UNITED STATES PATENT AND TRADEMARK OFFICE

Office Action Summary	Application No. 10/622,325	Applicant(s) CALDERWOOD ET AL.	
	Examiner Allen C. Ho	Art Unit 2882

DETAILED ACTION

Fig. 1

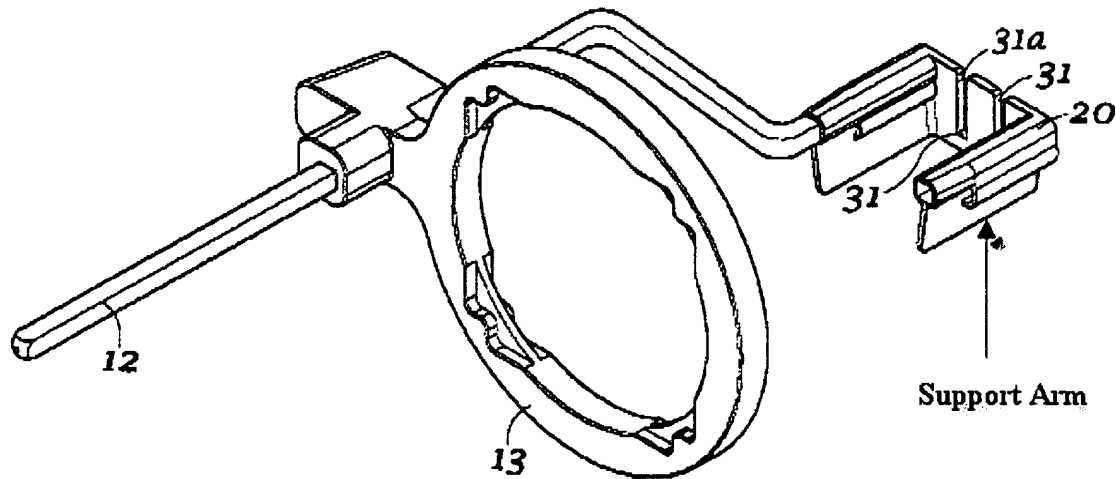
With regard to claim 19, Eppinger *et al.* disclosed a dental radiography anterior imaging bar comprising an aimer ring bar (12) supporting an anterior imaging platform; where the anterior imaging platform has two pressure slots (31, 40) and an angled base (20, 20a, 20b); and

where the aimer ring bar has an S-curve to support an aimer ring; and where the imaging platform further comprises two support arms extending from below the pressure slots to provide support to the anterior sensor holder (Fig. 1).
